DESIGN REVIEW COMMISSION AGENDA

Tuesday, September 17, 2024 – 6:30 P.M.

1. Chipotle, 6600 Stage Road (Shawna Fuhrman, Dungan Design Group)

DESIGN REVIEW COMMISSION
Tuesday, September 17, 2024 – 6:30 P.M.
Bartlett City Hall Assembly Chamber
Staff Comments

ELECTRICAL SITE
LIGHTING PLAN

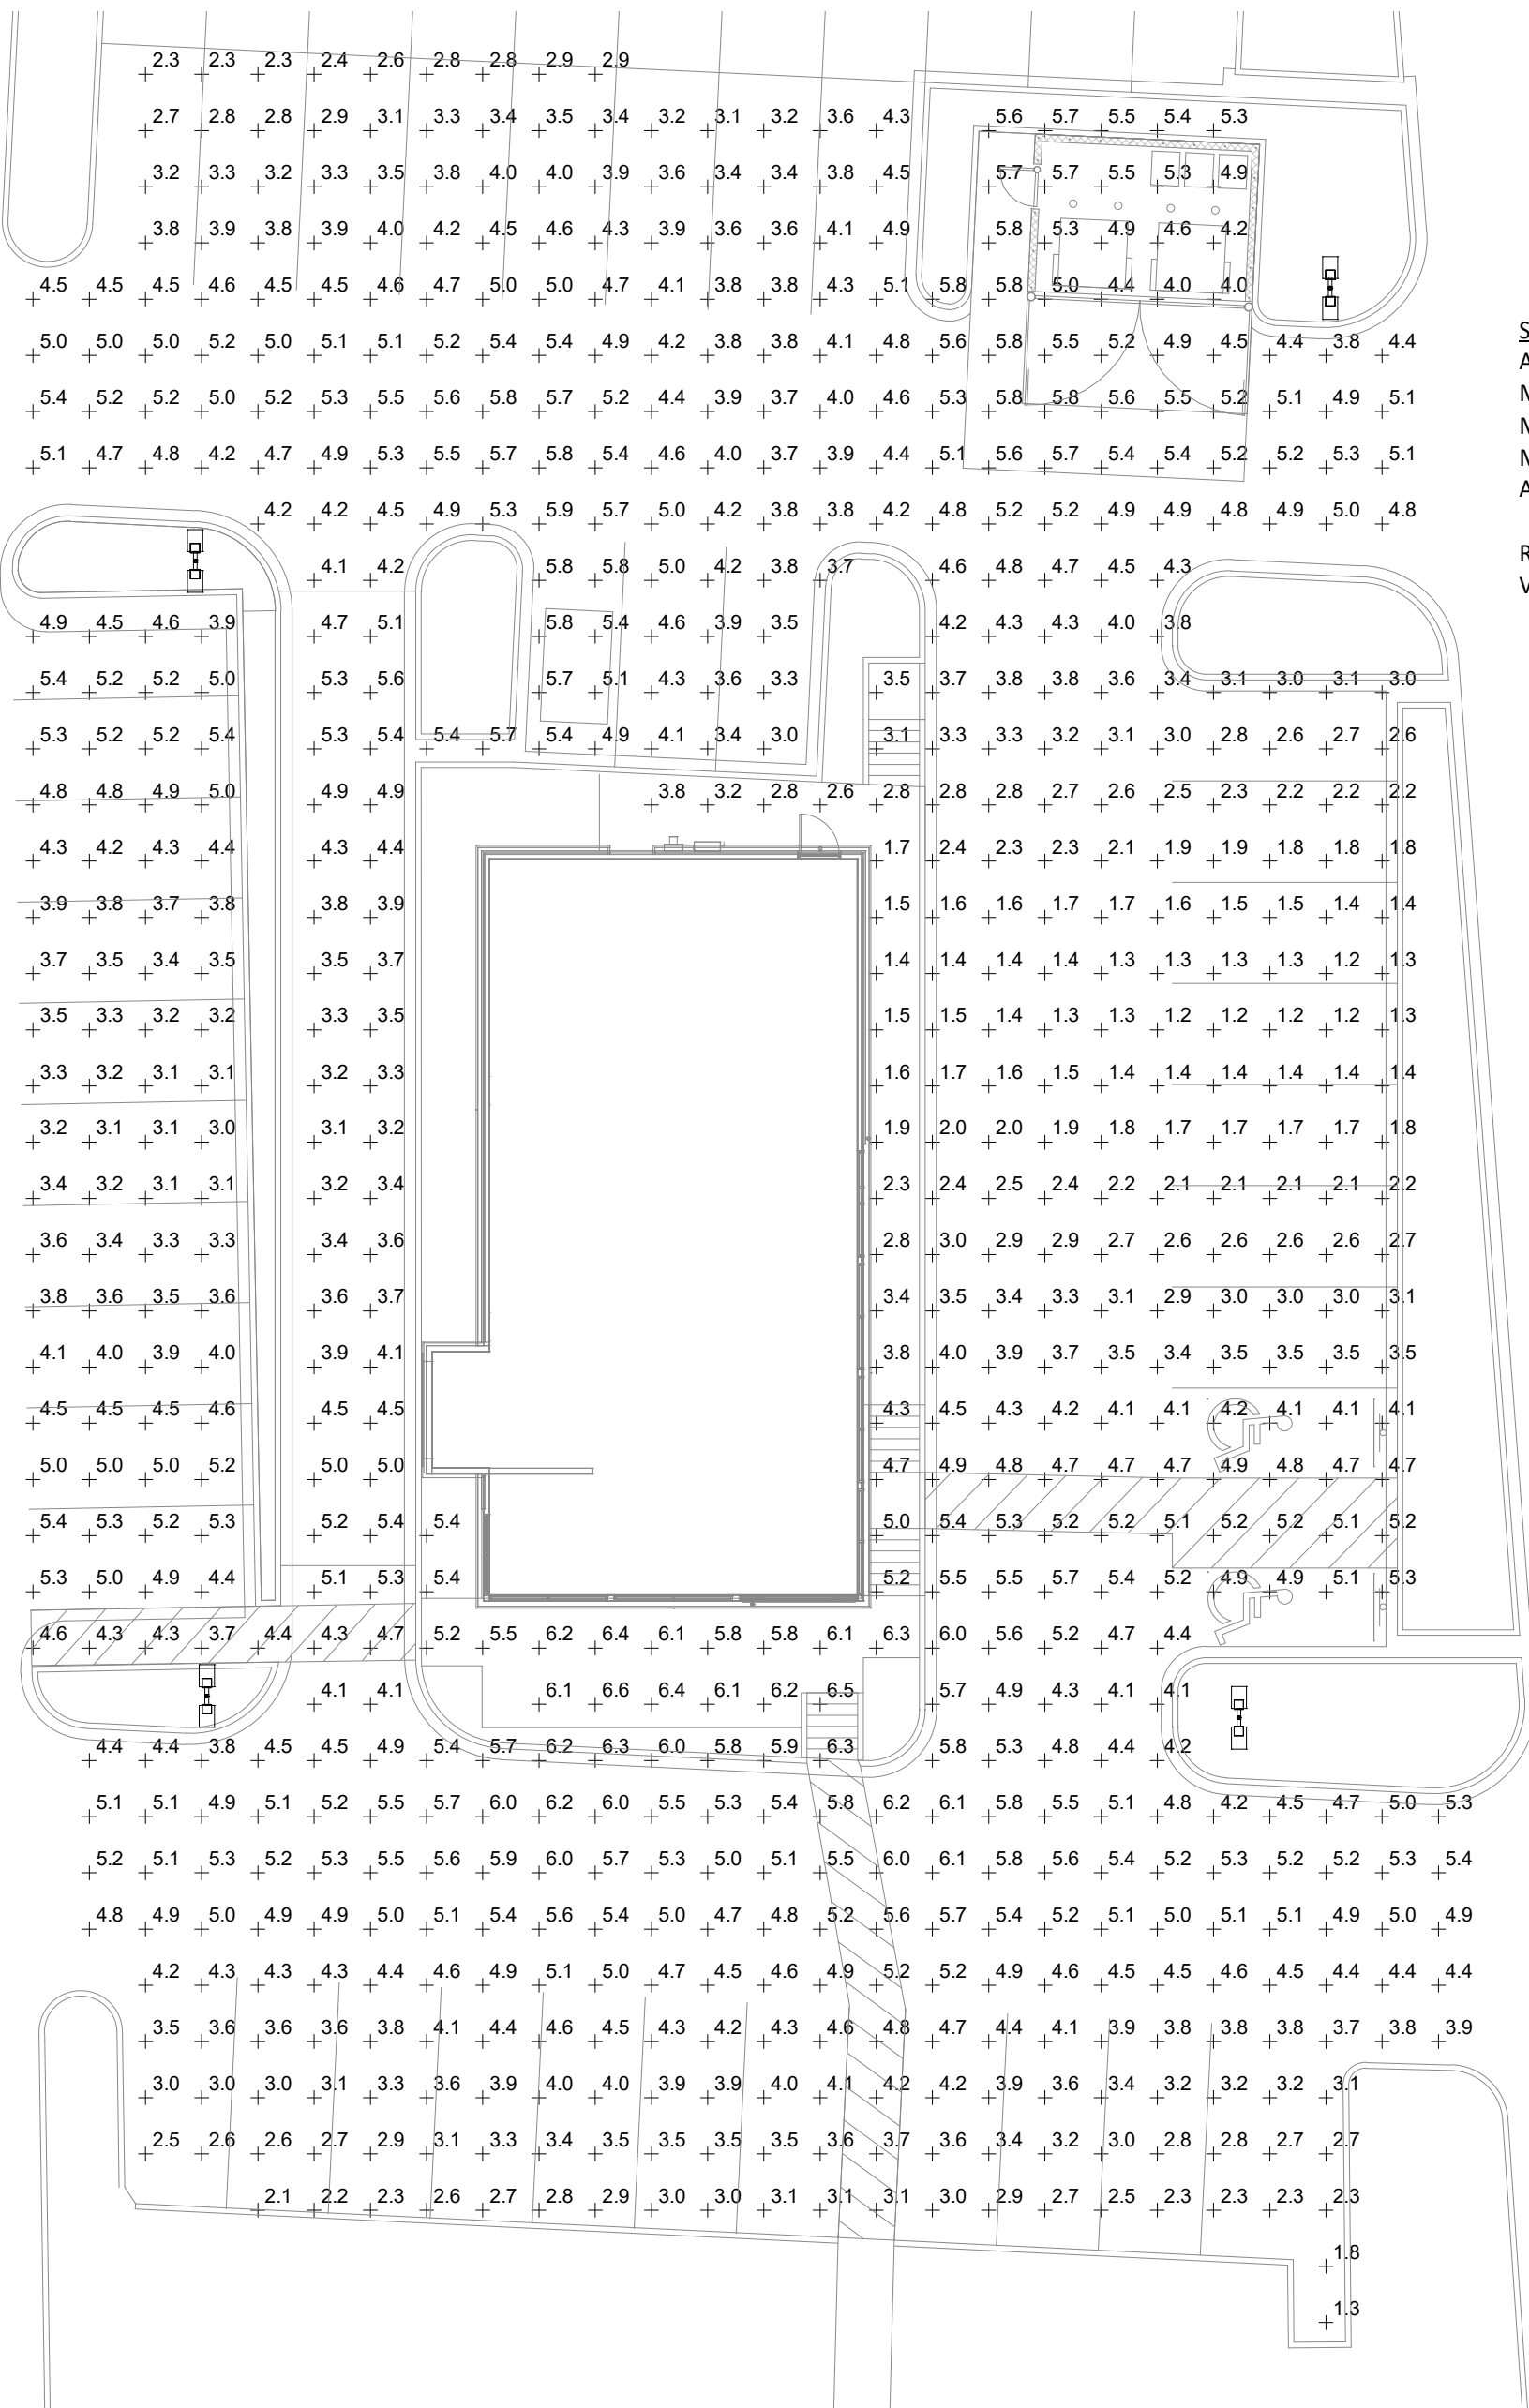
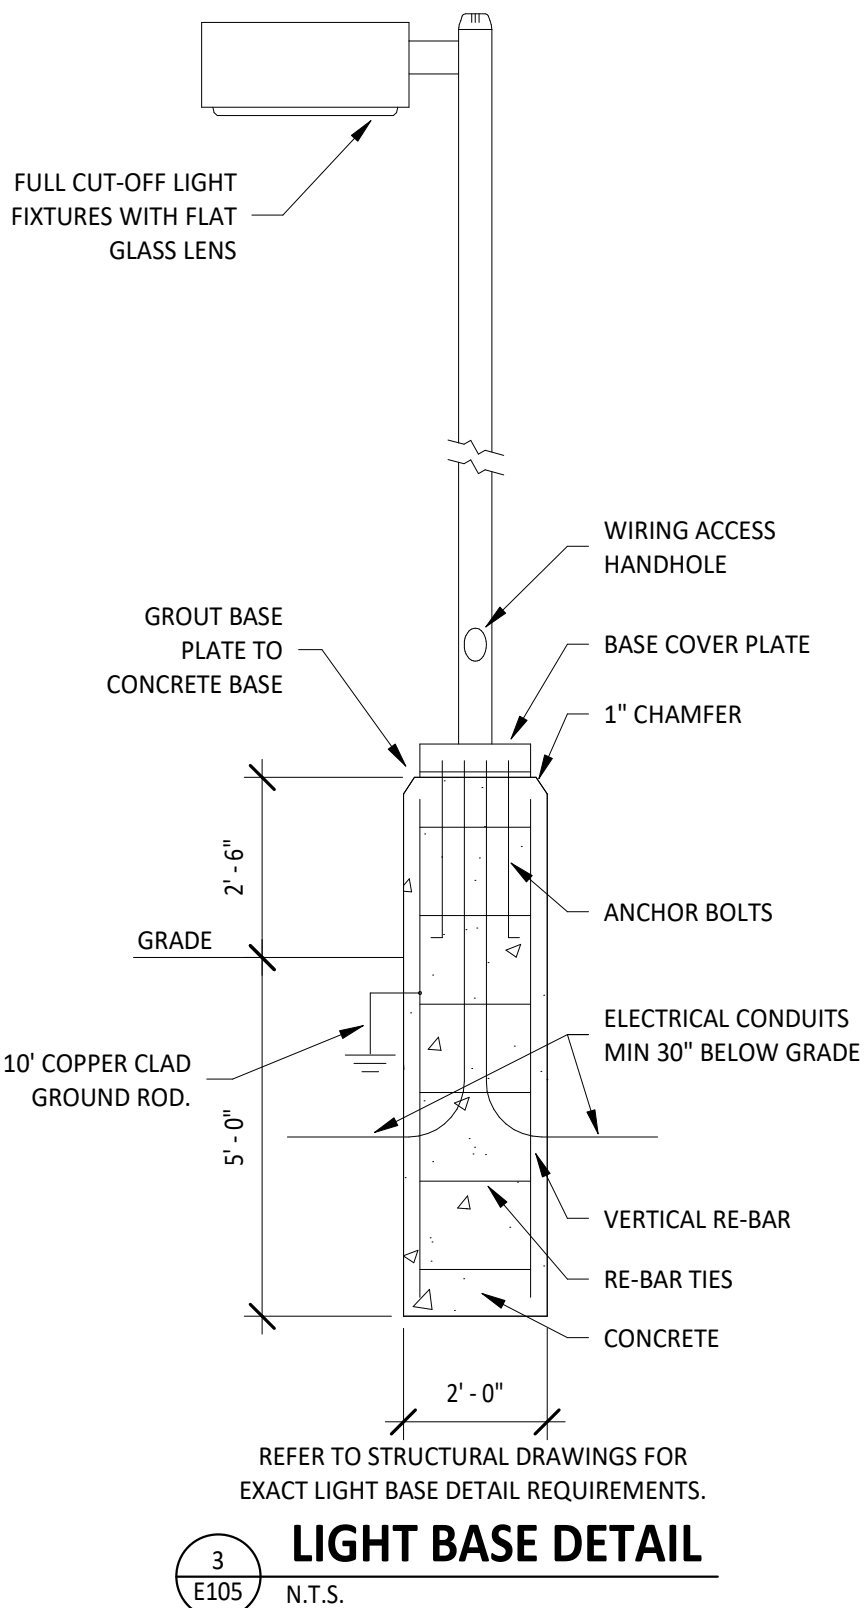
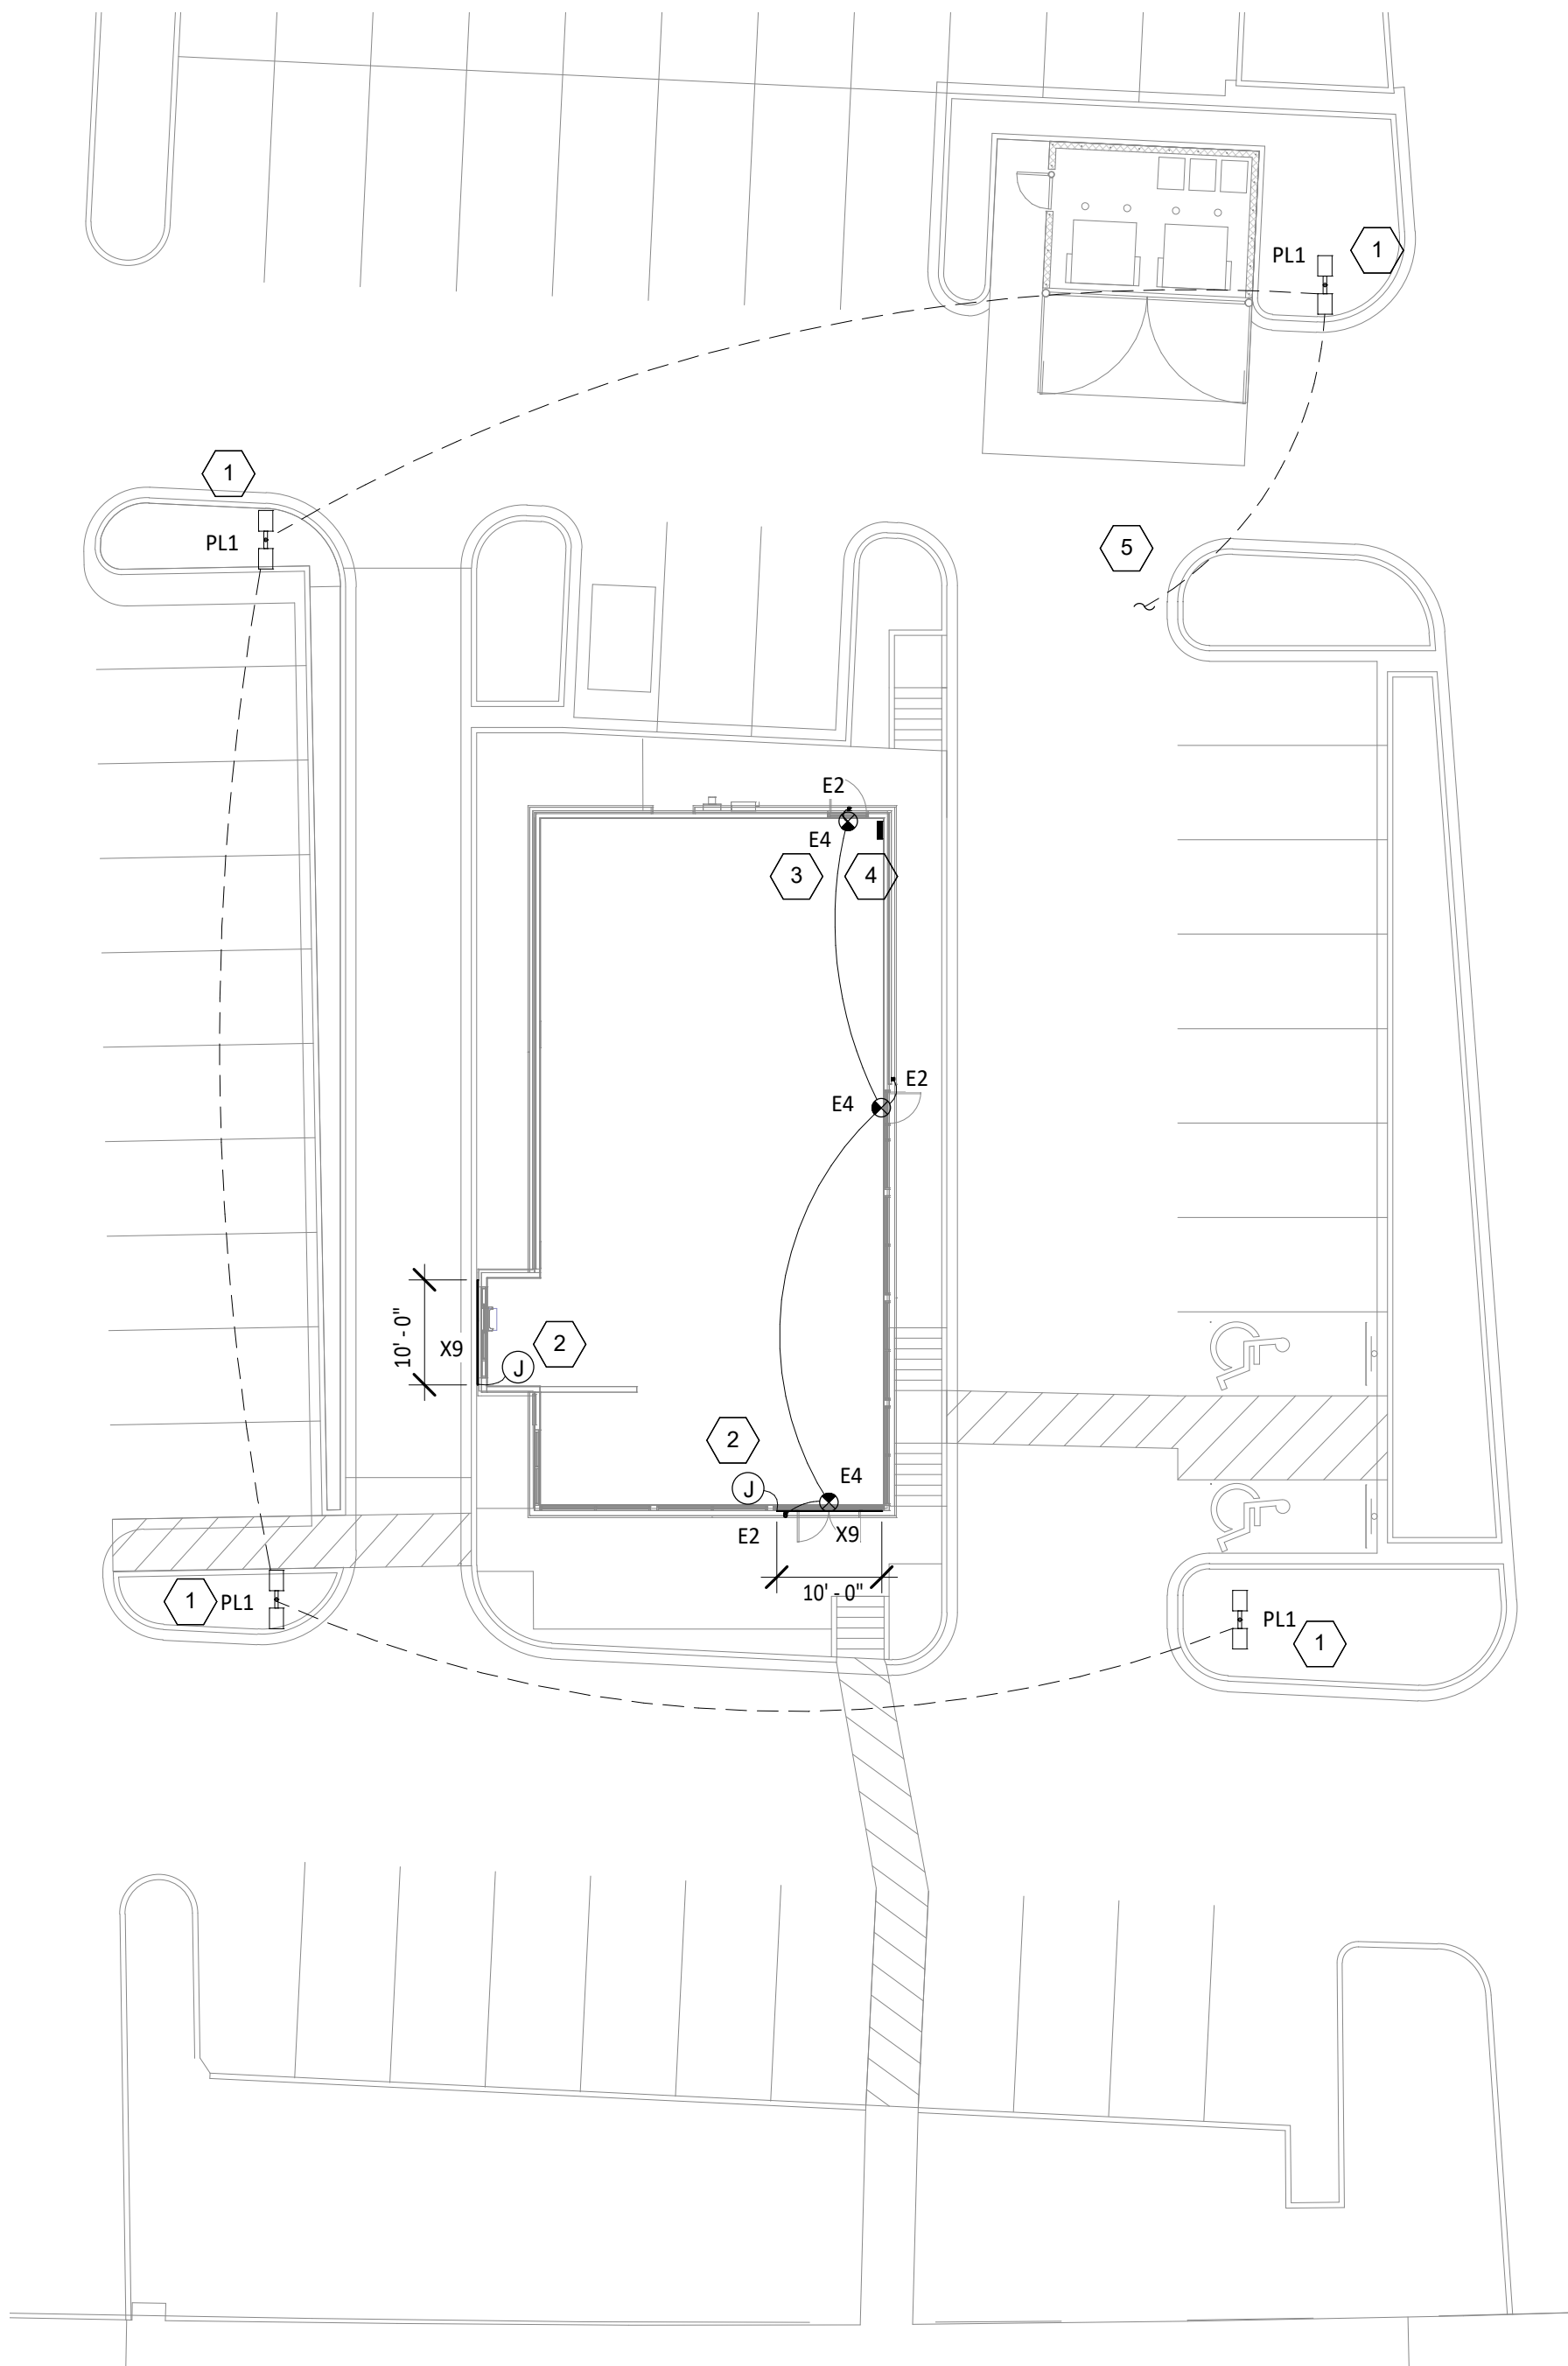
4. All exterior lighting shall be 4,000 K.
5. The applicant shall include lighting cut sheets and lighting temps to the Photometric Plan.
6. Maximum height for the proposed light pole, base, and fixtures shall not exceed 25 feet in height from the top of grade. Applicant shall show the total proposed light pole height on the light base detail.
